The City of Spartanburg Design Review Board

AGENDA

November 5th, 2024, at 5:30 P.M.

Meeting Minutes of the Design Review Board (DRB)
Tuesday, August 6th, 2024, at 5:30 PM
Dr. TK Gregg Recreation Center

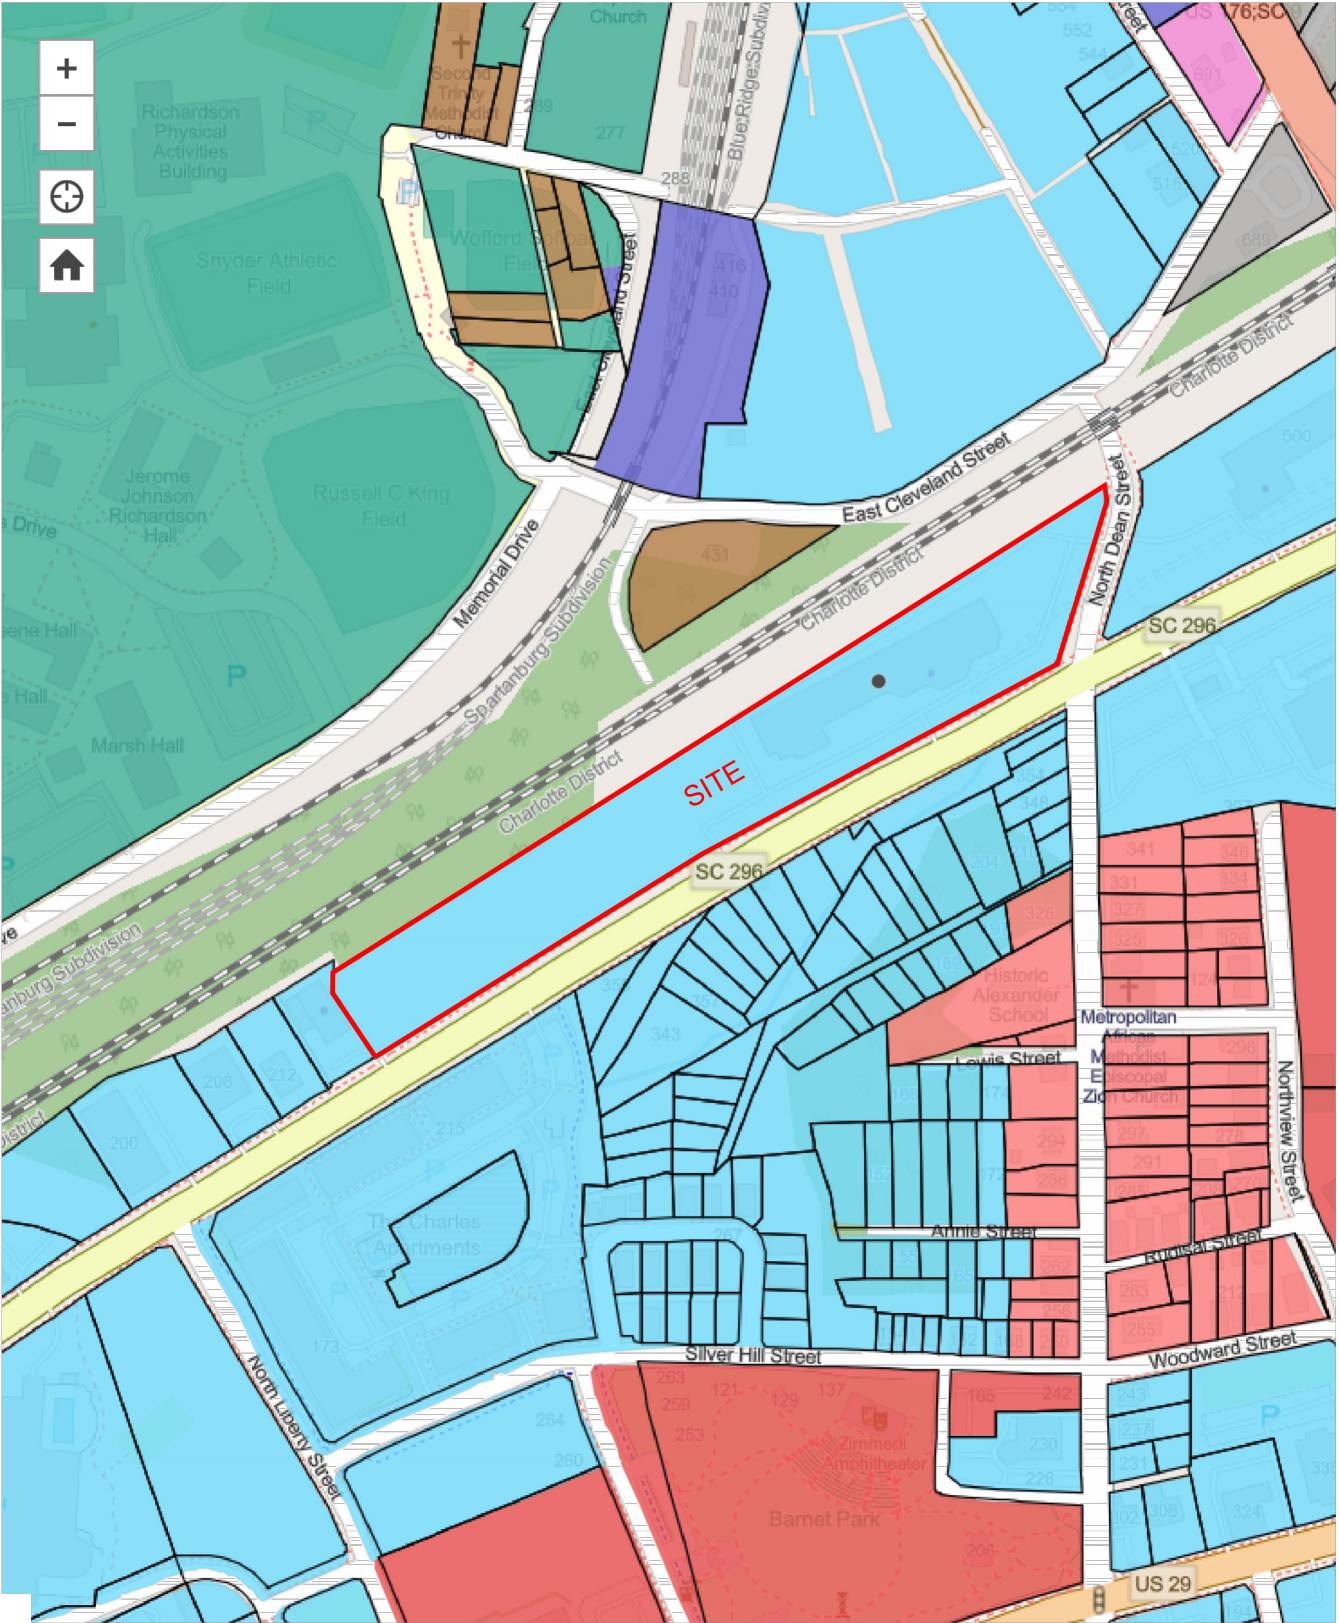
- **6.4.5 BUILDING MATERIALS:** The proposed expansion utilizes a metal paneling system similar to what is on the existing building. It is possible to provide an aesthetically appropriate brick veneer for all or a portion of the proposed expansion while keeping with the overall building style. Given that the overall frontage is quite wide, a change in material would provide a welcome relief to the long expanse.

- **8.1.1 STREETScape:** All streets must be planted with trees of species matching the planting on the public frontage as established by the City. Where no frontage detail has been established the following minimum elements shall apply. The City Engineer may grant a reduction in these dimensions subject to the overall context of the block (e.g., lack of opportunity for wider sidewalk on adjacent parcels). (The standard planting spacing for the City is every 50 ft on-center)

- No solution to this requirement has been provided.
 - Please remove the grass strip between the sidewalk and the curb to provide a minimum 6 foot wide sidewalk.

- **8.2.1 REQUIRED PLANTINGS:** One (1) Shade Tree and eight (8) shrubs per 10 parking spaces. No parking space shall be further than 60 feet from the trunk of a canopy tree.

1. Added five landscape islands along East Morgan Daniel/North Dean Street with shrubbery per your latest request.
2. Interior trees provided for parking area coverage.
3. Maintained existing parking in front of building while updating the front facade to be "flat", removing the bump out at the front entry. This was a Subaru request.
4. New smaller building footprint to reduce impact to site (from initial design).
5. Revised ADA ramp at exit on northeast side of building.
6. Revised new car delivery ramp on northeast side of building staying out of the flood plain.
7. Updated landscaping and landscape table and counts for new landscaping islands/areas.
